WF41 - Replacing Reservoir for the PDK Transmission (Workshop Campaign)

Vehicle Type: **918 Spyder**

Concerns: **Reservoir for the PDK transmission**

Removing reservoir

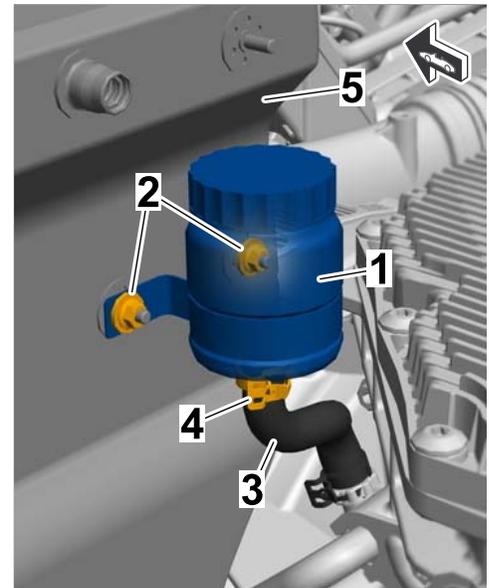
- 2 Remove reservoir ⇒ *Removing reservoir -1-* for the PDK transmission.

2.1 Loosen and unscrew fastening nuts ⇒ *Removing reservoir -2-* for the reservoir. Remove fastening nuts and washers.

2.2 Disconnect the reservoir ⇒ *Removing reservoir -1-* together with the retaining bar from the engine oil tank ⇒ *Removing reservoir -5-*.

2.3 Open the clamp ⇒ *Removing reservoir -4-* and disconnect the reservoir from the hose piece ⇒ *Removing reservoir -3-*. Then, remove the reservoir ⇒ *Removing reservoir -1-* together with the retaining bar.

Installing reservoir

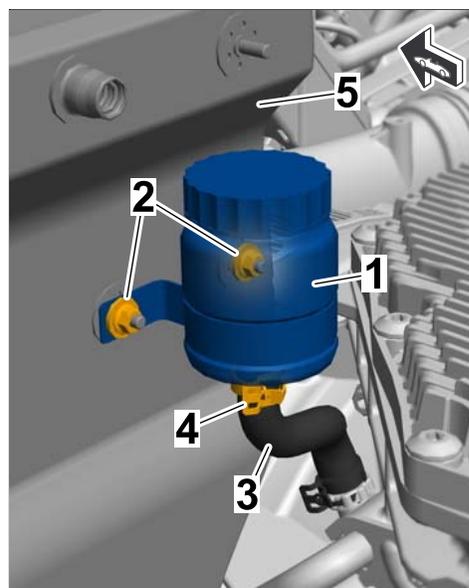
- 3 Install new reservoir ⇒ *Installing reservoir -1-* for the PDK transmission.
 - 3.1 Slide hose piece ⇒ *Installing reservoir -3-* as far as it will go onto the adapter on the new reservoir ⇒ *Installing reservoir -1-* and secure it with the clamp ⇒ *Installing reservoir -4-*.
Make sure not to twist or crush the hose piece when fitting the reservoir.
 - 3.2 Position new reservoir ⇒ *Installing reservoir -1-* using the retaining bar on the pin caps on the engine oil tank ⇒ *Installing reservoir -5-*.
 - 3.3 Fit washers on the pin caps. Screw on and tighten fastening nuts ⇒ *Installing reservoir -2-*.
Tightening torque 6 Nm (4.5 ftlb.)

Action Required: Replace reservoir for the PDK transmission with a modified reservoir with a securely bonded cap and without the markings/information.
